Individual Permit Applicationfor a **Lake Encroachment Permit** under
Chapter 11 of Title 29, § 401 *et seq.***For Lake Encroachment Permitting Use Only**Application Number: 2016-010VERMONT DEPARTMENT OF
ENVIRONMENTAL CONSERVATION
**WATERSHED
MANAGEMENT DIVISION**
LAKES & PONDS PROGRAM

Wallace Pond

PROPOSED RETAINING WALL
 DATE: 4/25/16
 Revised July 13, 2016

- 15 CODE A BASKETS = (6' Long) X (3' Wide) X (3' High)
- 11 CODE B BASKETS = (9' Long) X (3' Wide) X (3' High)
- 5 CODE D BASKETS = (6' Long) X (3' Wide) X (1.5' High)
- 1 CODE E BASKET = (9' Long) X (3' Wide) X (1.5' High)

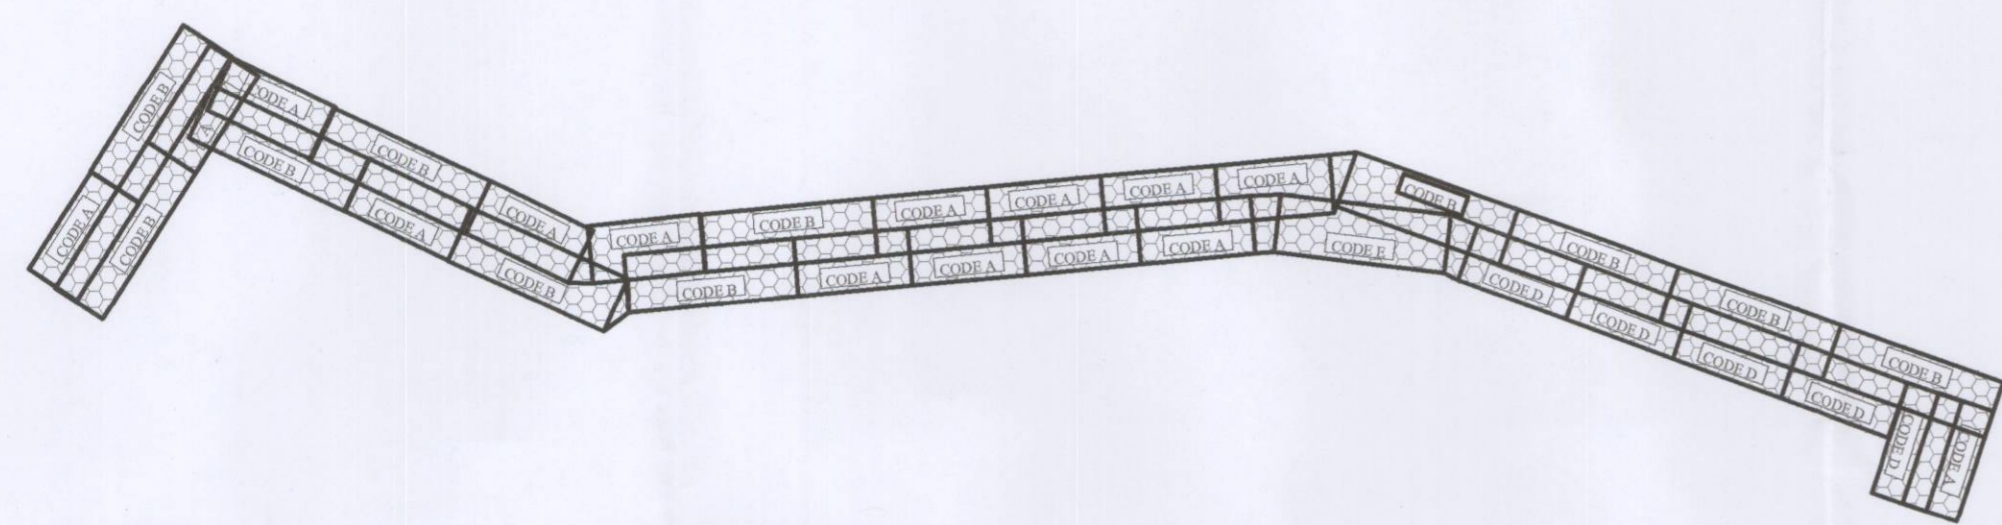
Thanks for provided the rock size and total cubic yards. Can you estimate the number of cubic yards of 6" rocks that will be sloped in front of the baskets beyond mean water level?

- 1) Replacing a vertical wall with sloped rip-rap is a preferable alternative for shoreline stabilization projects, but can you please state the purpose of also using gabion baskets?
- 2) What is the size, amount, and overall slope of the fill material (rip-rap) placed beyond the shoreline at mean water level?
- 3) What is the length of shoreline associated with this project?
- 4) Will there be vegetation planted on top to aid in stabilization?
- 5) When is the project planned to begin? (Note: Lake Encroachment projects are not to commence until after fish spawning July 1 of any calendar year.)
- 6) Can you please provide photos of the project area?

Hi Mark, the amount of stone placed in front of baskets will be approximately 45* yards however stone will be placed on top of the first basket which on the project plans is stepped back to keep baskets from wanting to tip forward. Thank You Jimmy

Good Morning Mark, the rock used to fill Gibeon Baskets will be no smaller than 6" and no bigger than 2' but the rock used to slope in front of baskets will be 6". Approximately 250 yards of stone will be used on project. I have talked to Norman Brooks he's a foreman for winterset Construction he has installed these baskets through the state of Vermont and NH and was very helpful in giving me some good pointers in installing these baskets. Thank You Jimmy

The reason for baskets is because of height of wall. The slope will be between 3/1 but at no time more than 2/1. The shoreline distance is roughly 150 feet. Grass will be planted over top of baskets. Project would begin in July. I'll send pics when I get chance. Thanks Jimmy

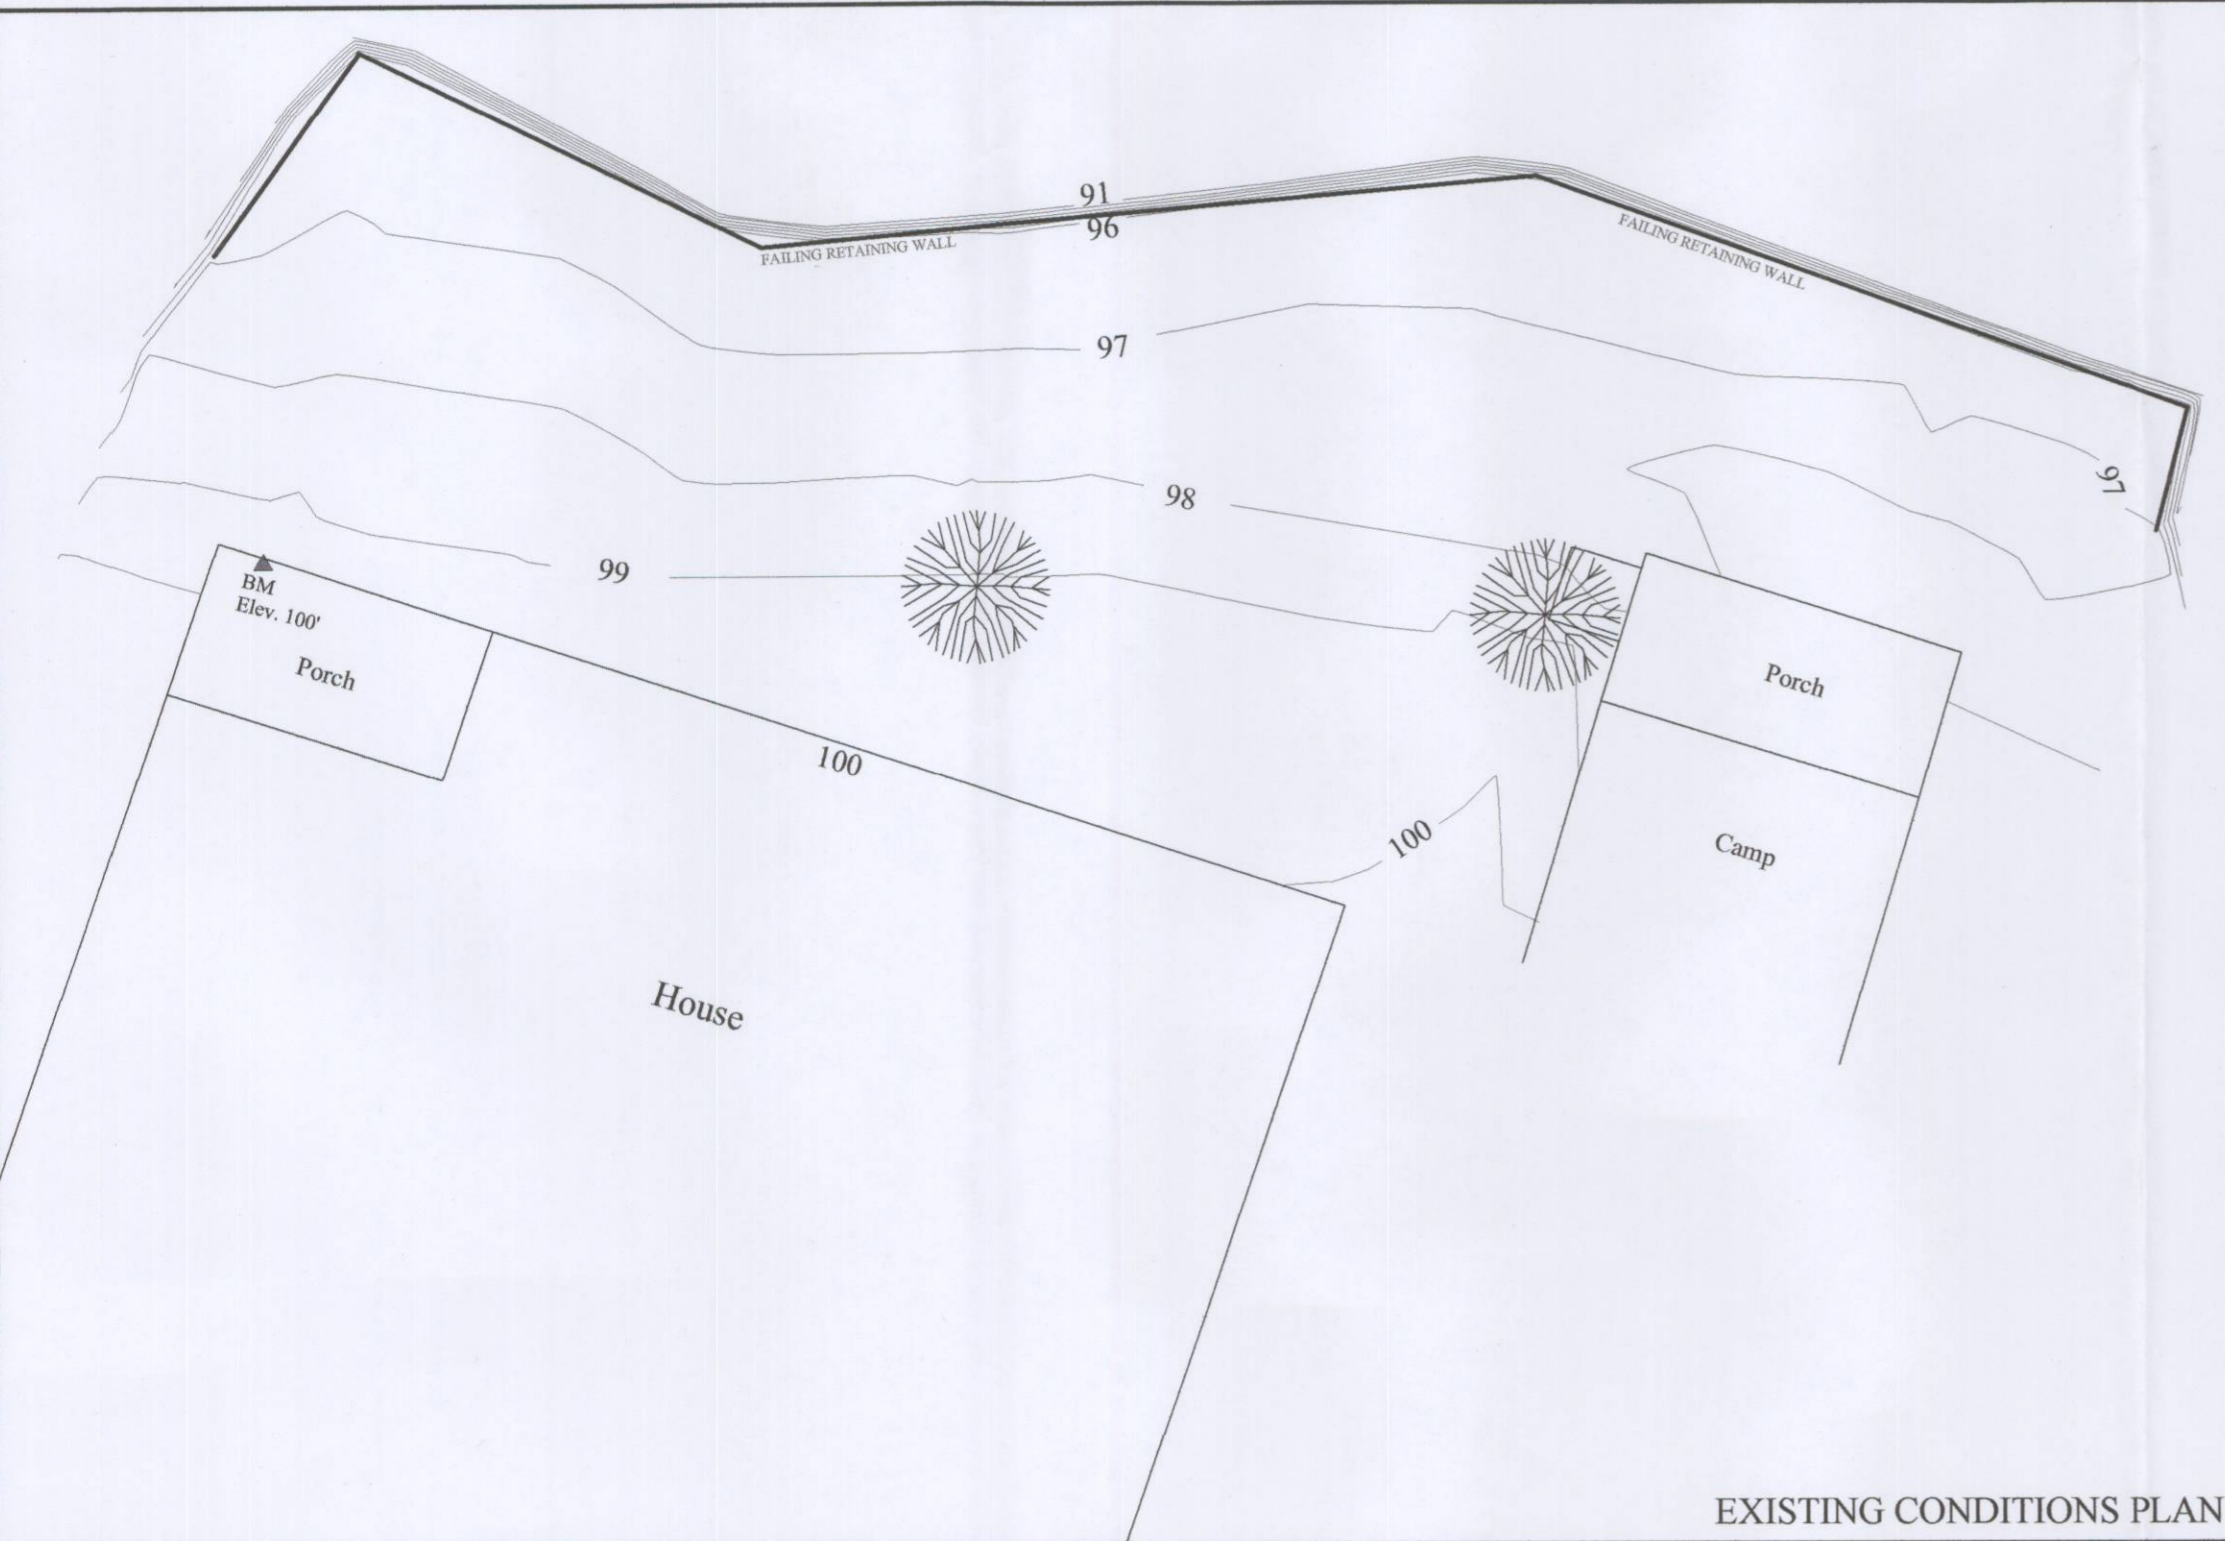
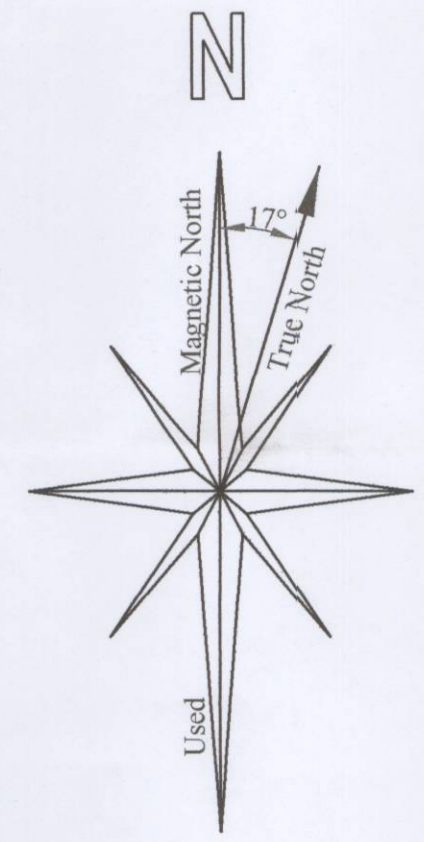
Amended Plans
 Changed Block Layout
 18" Basket on Bottom
 With 3' Basket on Top
 This Will reduce the amount
 of Rip Rap in front
 of the Baskets

I'm following up on the conversation we had last week. Per our discussion, we concluded an updated site plan would be produced that shows the gabion basket at the mean water level to be 18" tall as opposed to original design of 3' tall. Please also include with these updates how the rip rap in front of the baskets will be reduced in volume as well as reducing the distance out into the lake beyond mean water level the rip rap will go by providing updated values where applicable.

Hi Misha, having changed the size of basket to 18" on the bottom should cut the amount of stone in half that will be used to slope down in front of them. We proposed 45 yards with the 3' baskets so now it would be reduced to 22.5 yards. Let me know if you have any other questions. Thanks Jimmy
